Proposal for the 03 series of amendments to UN Regulation No. 100

The text reproduced below was prepared by the expert from the Russian Federation in order to identify electric vehicles. The changes to the current text of UN Regulation No.100 are given in bold (new provisions) or crossed out (deleted elements).

Figure 11.1 - Placement on a vehicle of category M1

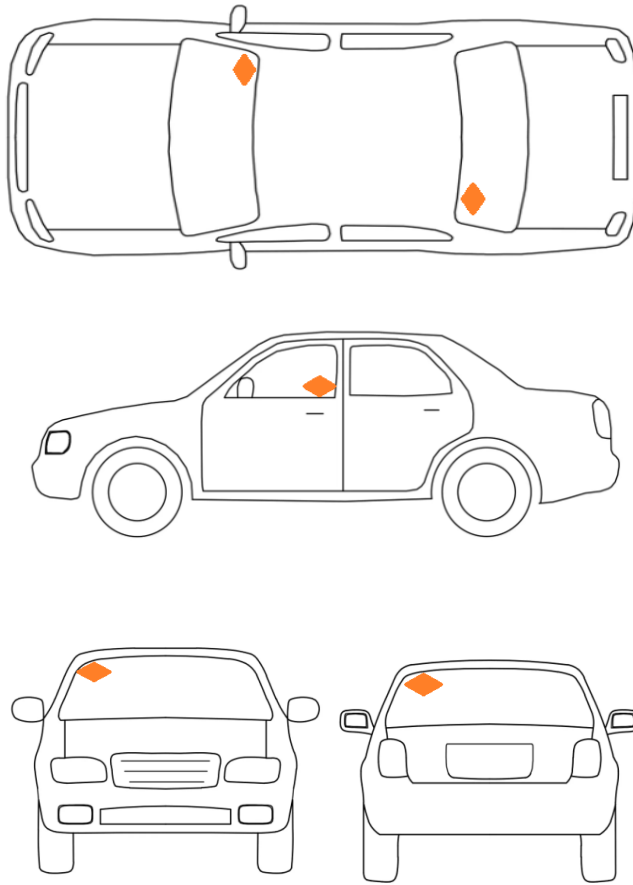
The identification sticker on the vehicles of categories M1 and N1 shall be placed on four sides (Figure 11.1, 11.3):

- at the front: upper corner of the windscreen from the passenger side;
- on the right and on the left: in the lower corner of the side window near the B-pillar of the body;
- at the rear: upper corner of the rear window from the driver side. In case of absence of the rear window, on the rear part of the body from the driver side.

Figure 11.2 - Placement on a vehicle of categories M2 and M3

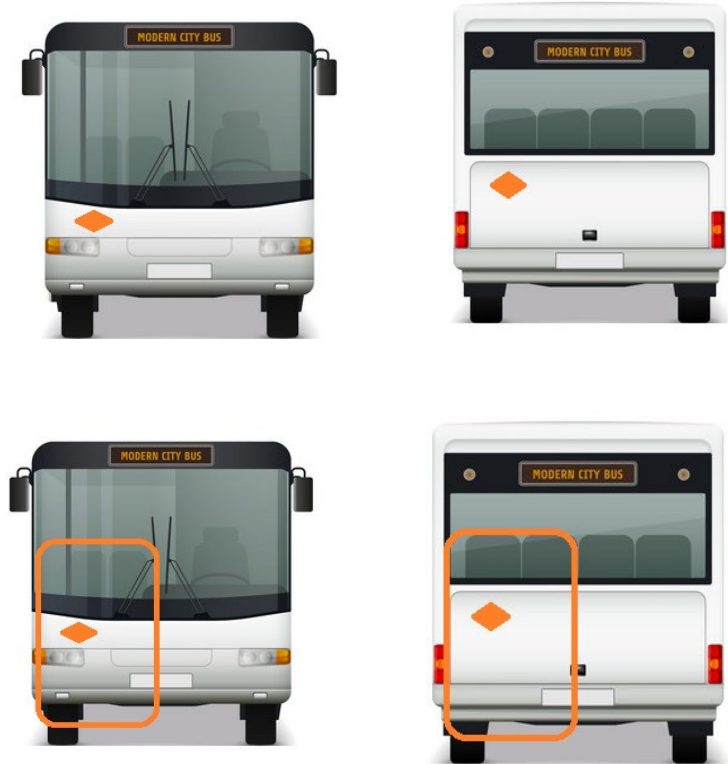
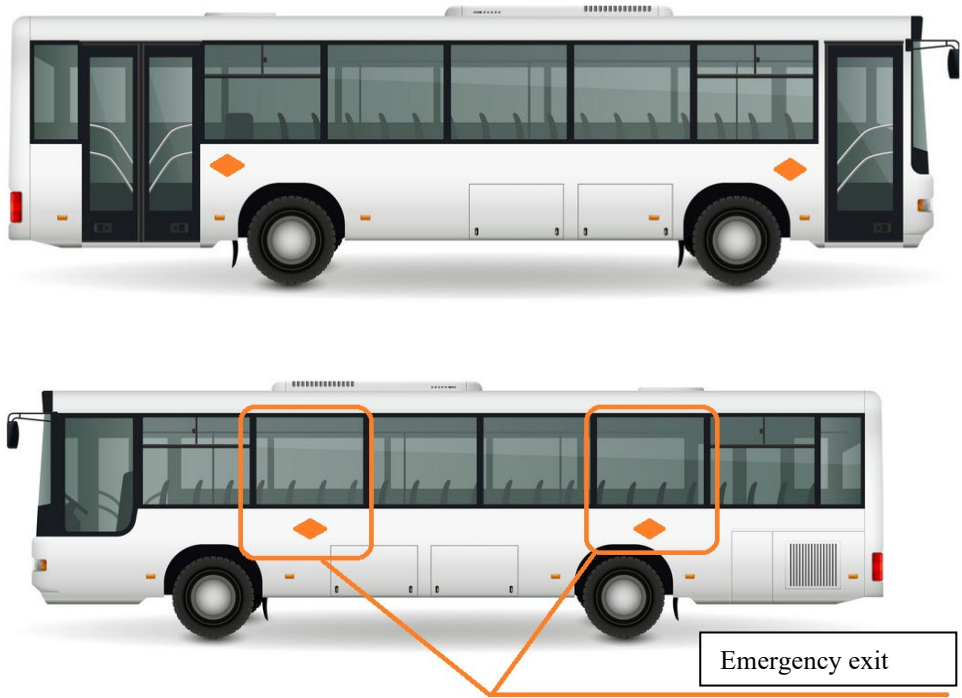
The identification sticker on the vehicles of categories M2 and M3 shall be placed on four sides and optionally on the roof (Figure 11.2):

- at the front: from the side of passenger compartment doors on the windscreen or the body (the sticker shall contrast with the background);
- at the rear: from the driver side on the rear window or the body (the sticker shall contrast with the background);
- on the right and on the left: on the outside of the doors on the right side (in case of the vehicles intended for left-hand traffic) or on the left side (in case of the vehicles intended for right-hand traffic) as well as on the opposite side at the emergency exits
- at the top: on the roof next to the emergency exit

Figure 11.4 Placement on a vehicle of category N2

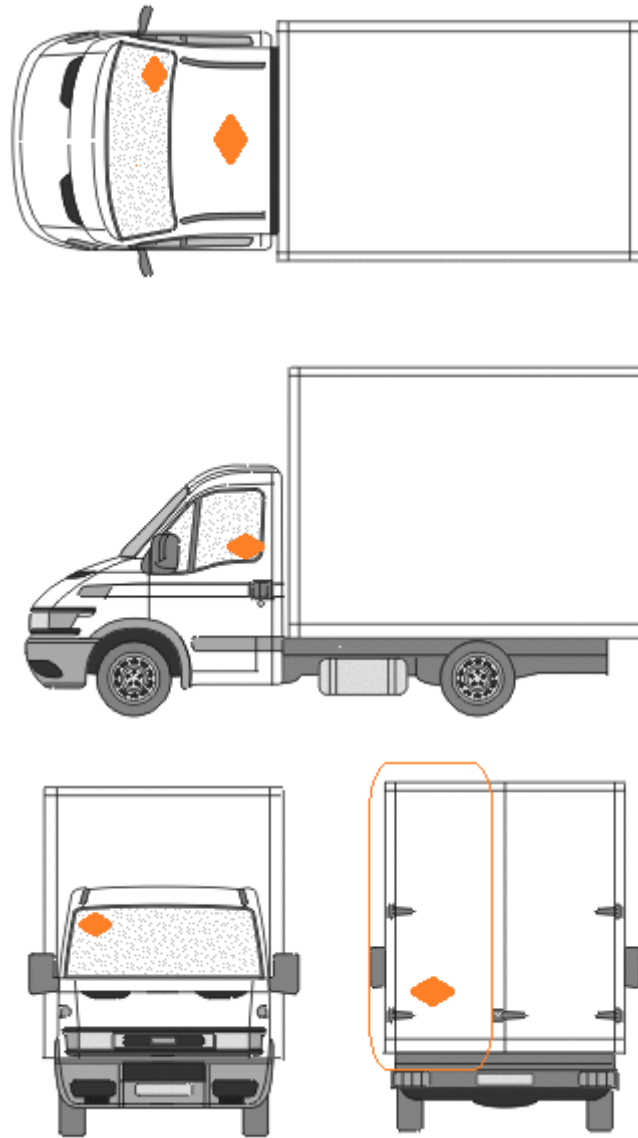
The identification sticker on the N2 category vehicles shall be placed on four sides and optionally on the roof (Figure 11.4):

- at the front: upper corner of the windscreen from the passenger side;
- on the right and on the left: in the lower corner of the side window near the B-pillar of the body;
- at the rear: upper corner of the rear window from the driver side. In case of absence of the rear window, on the rear part of the body from the driver side.

Figure 11.5 Placement on a vehicle of category N3

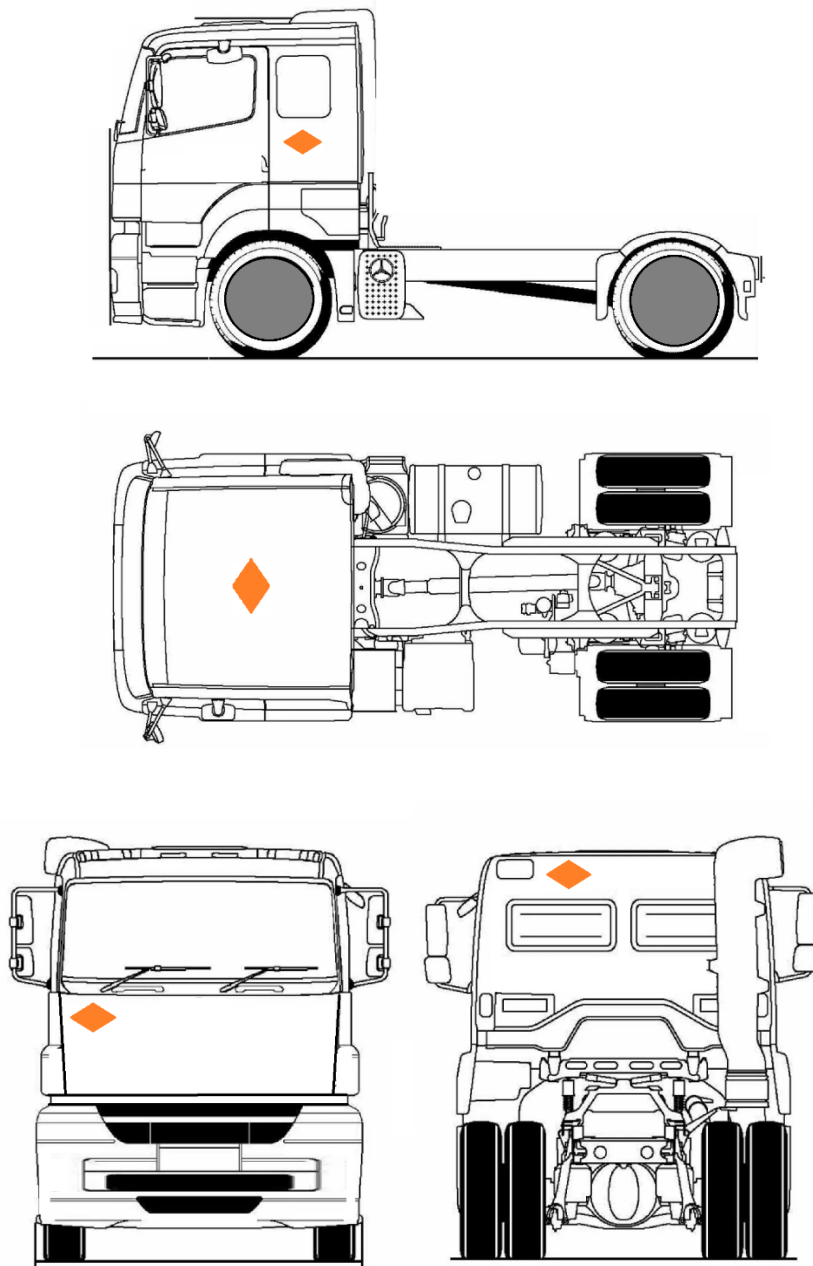
The identification sticker on the N3 category vehicles shall be placed on four sides and optionally on the roof (Figure 11.5):

- at the front: from the passenger side on the windscreen or the body (the sticker shall contrast with the background);
- on the right and on the left: on the outside of the doors
- at the rear: upper corner of the rear window from the driver side. In case of absence of the rear window, on the rear part of the body from the driver side.
- at the top next to the emergency exit.
